Re: Letter of Introduction for The Aurora Highlands Site Plan No.21 / Filing No.21

THE AURORA HIGHLANDS SITE PLAN #21

RE: Transportation Impact Study - Revised
The Aurora Highlands – Planning Area 70 (Century)

THE AURORA HIGHLANDS SP #21
TITLE: L3.01 - MASTER FENCE & TRAIL PLAN
DATE: AUGUST 25, 2022

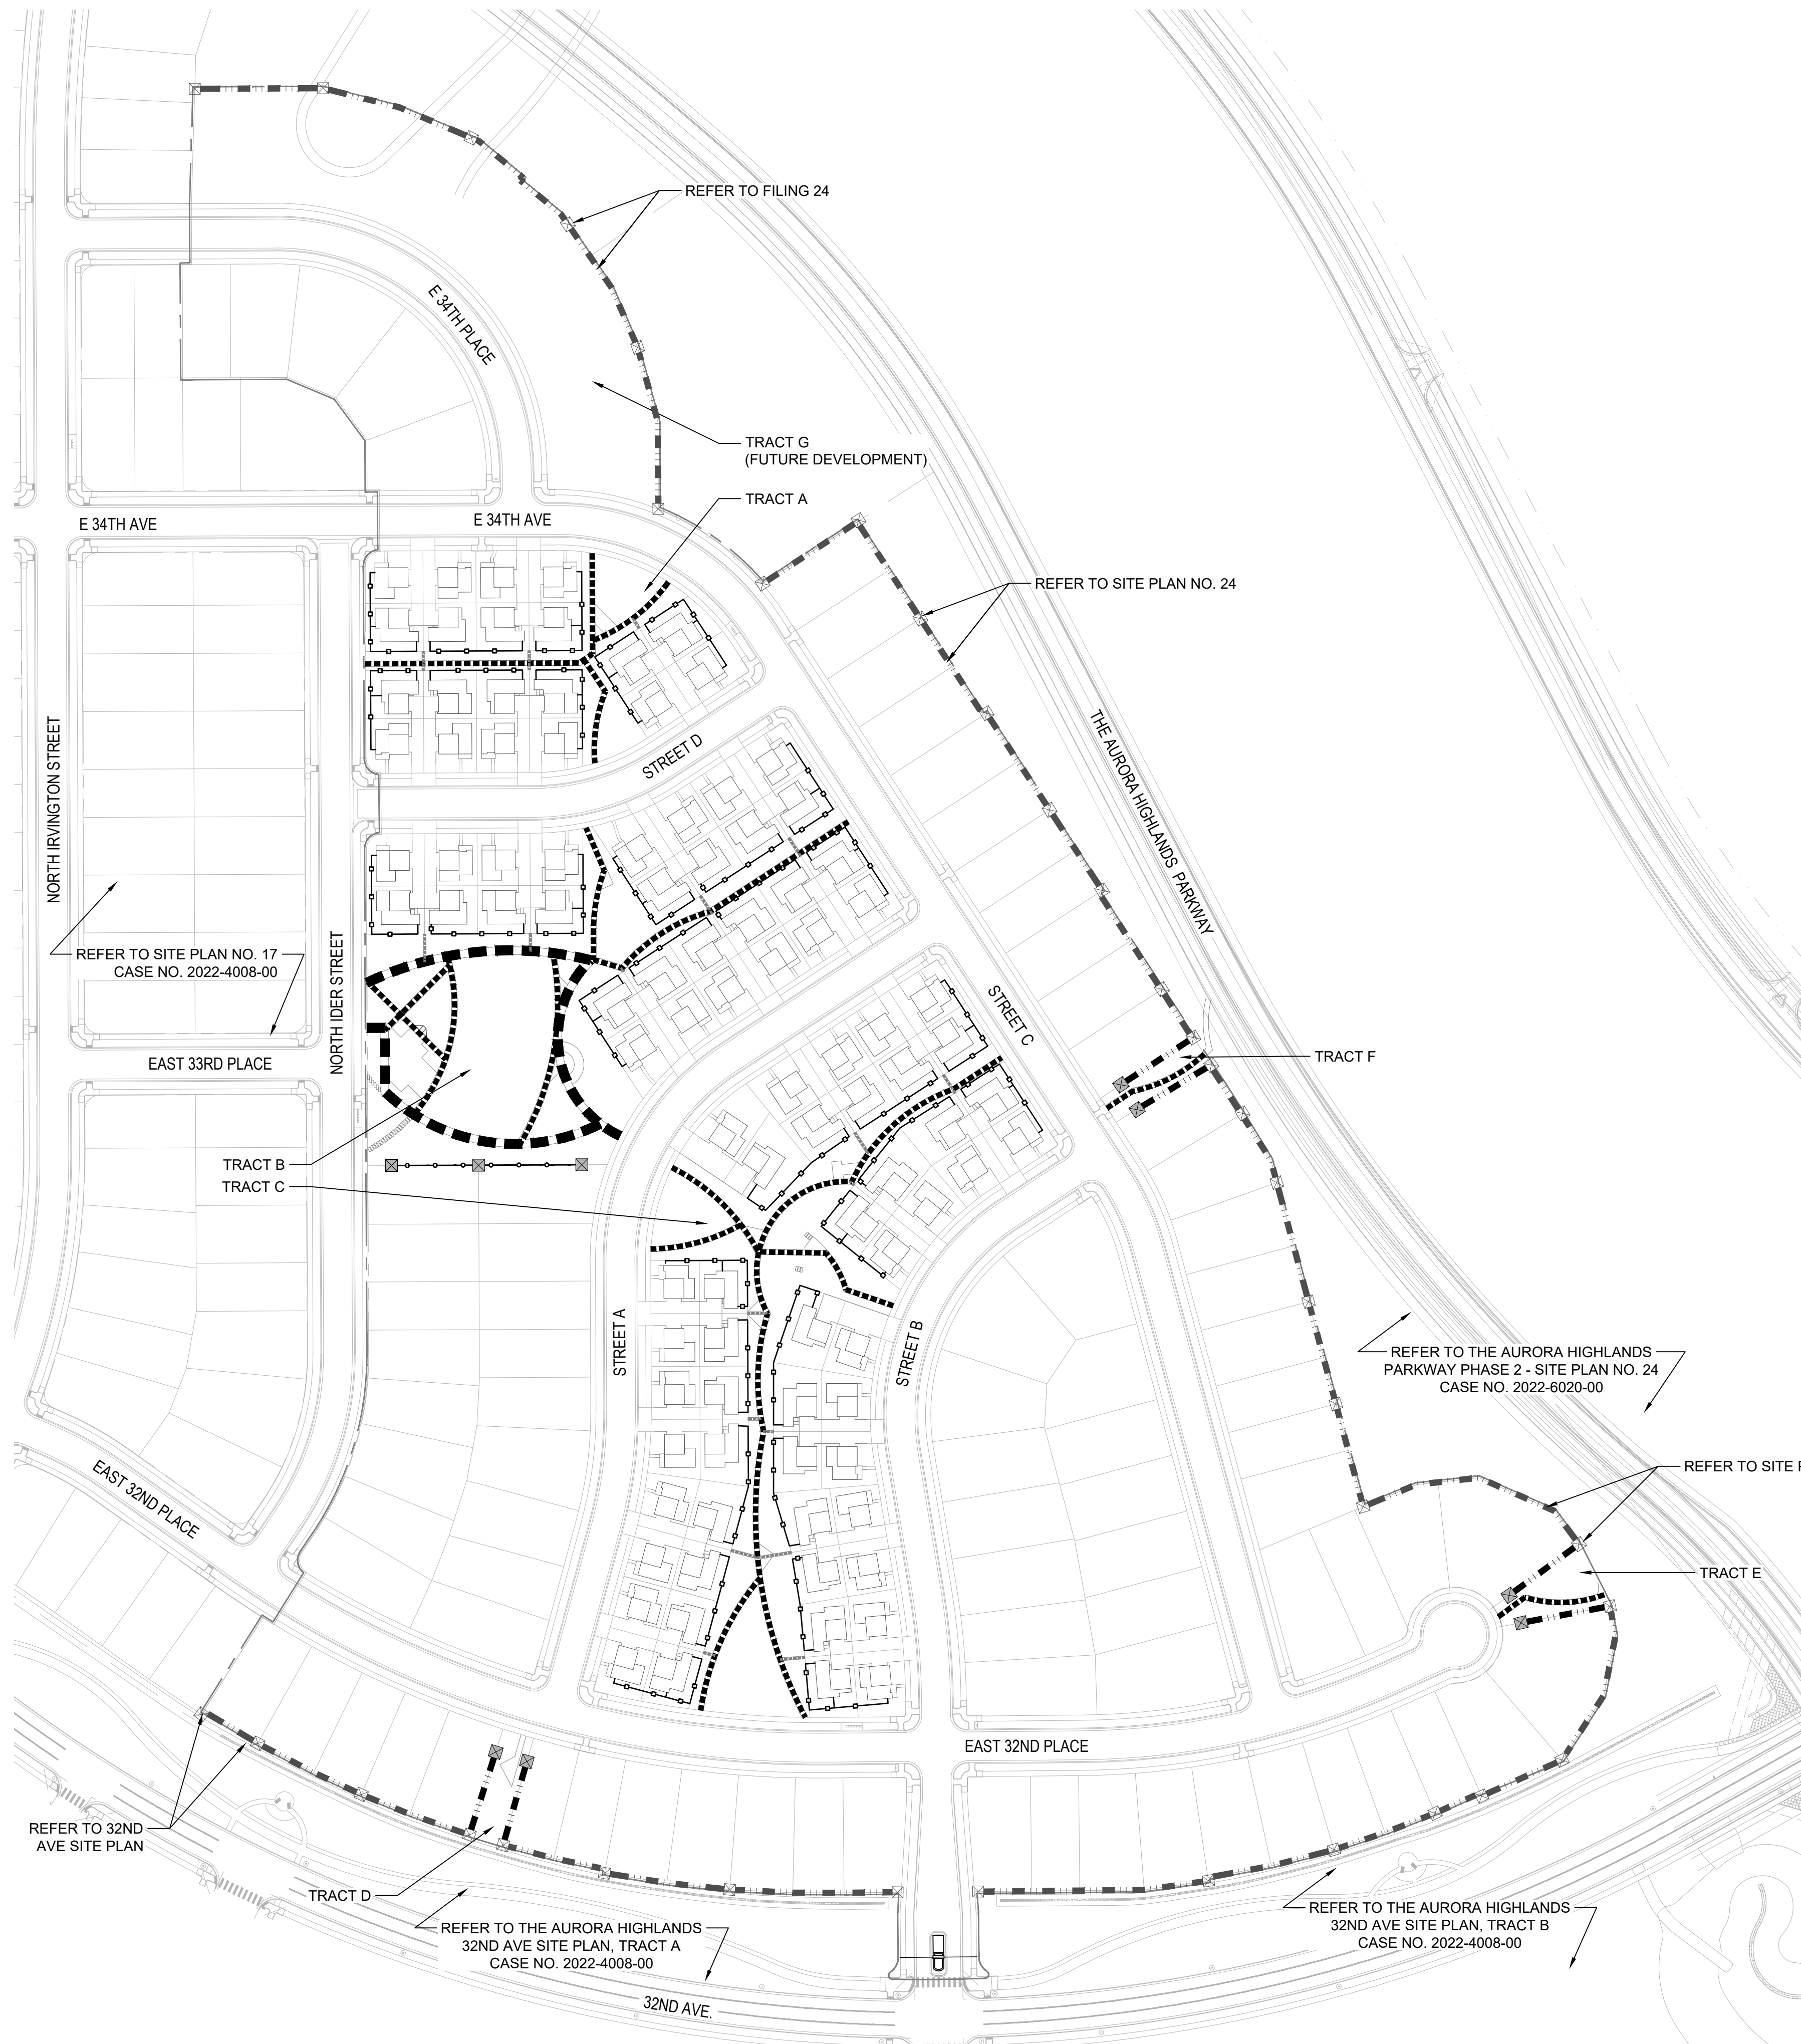
symbols are too similar. Revise one

ND Response: Symbols have been revised

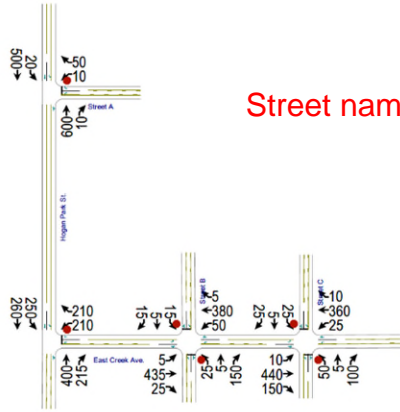
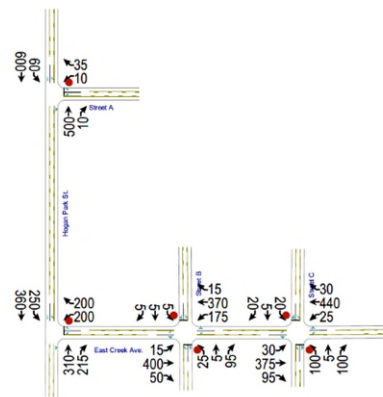
Still have issues with this paragraph. If anything, the FHU study was more aggressive with timeline, as it presumes the full build out of the area to occur prior to 2040, whereas NEATS assumes build condition to be post-2040 (i.e. NEATS Figure 10 showing buildout ADT at ~22k). This paragraph is using this discrepancy to presume that less traffic will be anticipated for 26th than the FHU study projected. Revise this paragraph as such.

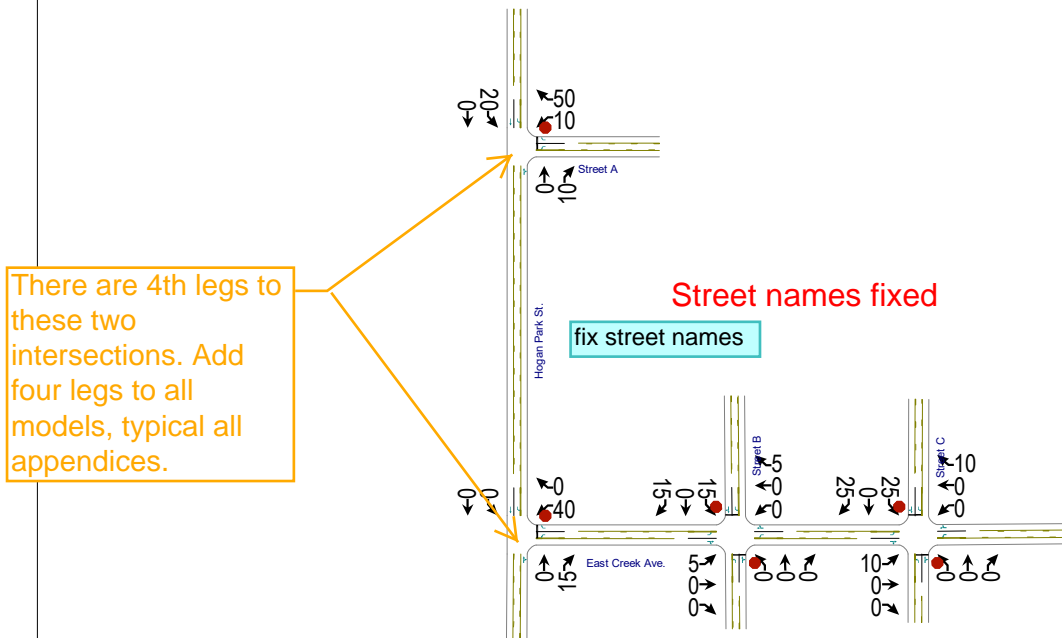
Is this for signalized operations?

The lane geometry was revised in the December 7, 2022, TIS to include a fourth leg at the 32nd/Highlands Creek intersection and match the F9 study. We have no information to add a fourth leg to Street A.
